Draft v2

Bristol Civic Society response to the Temple Meads southern gateway consultation

February 2025

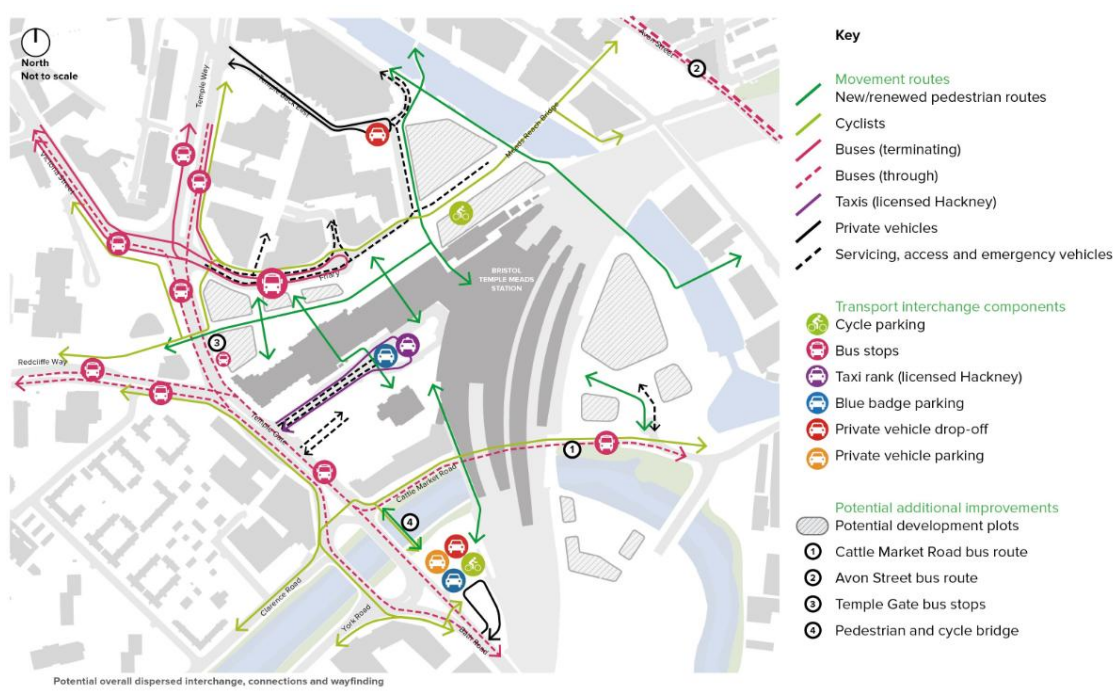
- (1) Much more analysis is needed to show that it is workable. We await detailed design and analysis in the planning application (due in April) to demonstrate that the traffic flow impacts, car park operation, and collision risks can be well-managed and mitigated against. (We will also wait for the planning application to enable us to comment on the detailed design of the buildings.)
- (2) We think the walkway should be covered
- (3) We think that there is a missed opportunity in that the Council is not reviewing the configuration of Bath Bridges roundabout at the same time.

The figure below shows the proposed overall transport interchange detailed routes and stops for different modes of transport:

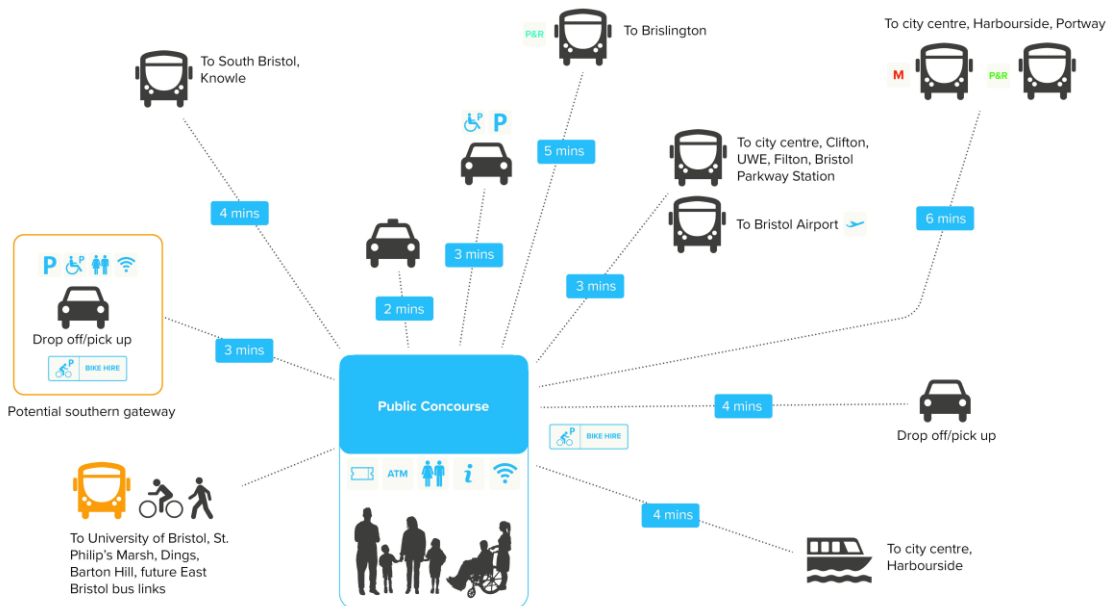
In previous consultations we have supported the TQDF plan as follows:

“We support:

- pedestrians being placed at the top of the transport hierarchy*
- the larger public realm area outside the entrance at the top of the ramp (currently the domination of the public realm close to the entrance by taxis, and the associated pollution from idling vehicles, is unacceptable even if they are Euro 6)*
- the large public realm area between the Brunel Mile crossing of Temple Gate and the northern entrance*
- for disabled travellers and other drivers, the new level station access from the planned new permanent car park on the Kwik-Fit site on Bath Road south of the river*
- the decision not to allow a through-route for bus and private motor traffic from Temple Back East to the Friary.*

The configuration of connection points to taxis, buses and private cars is sub-optimal, but probably the best that can be achieved given the physical constraints.”

In addition, we now note that the TQDF plan also takes away the need for traffic coming from the south for drop-off on the Station Approach to travel via Redcliffe Hill and Redcliffe Way, except for taxis. By taking drop-offs away from the Approach, it reduces the 'stop' time on Temple Gate at the traffic lights at the junction with the Approach. And reduces traffic on Redcliffe Way, which helps to 'calm' Redcliffe Way, which has been a long-term aim of the Society and local groups like Redcliffe Forum.
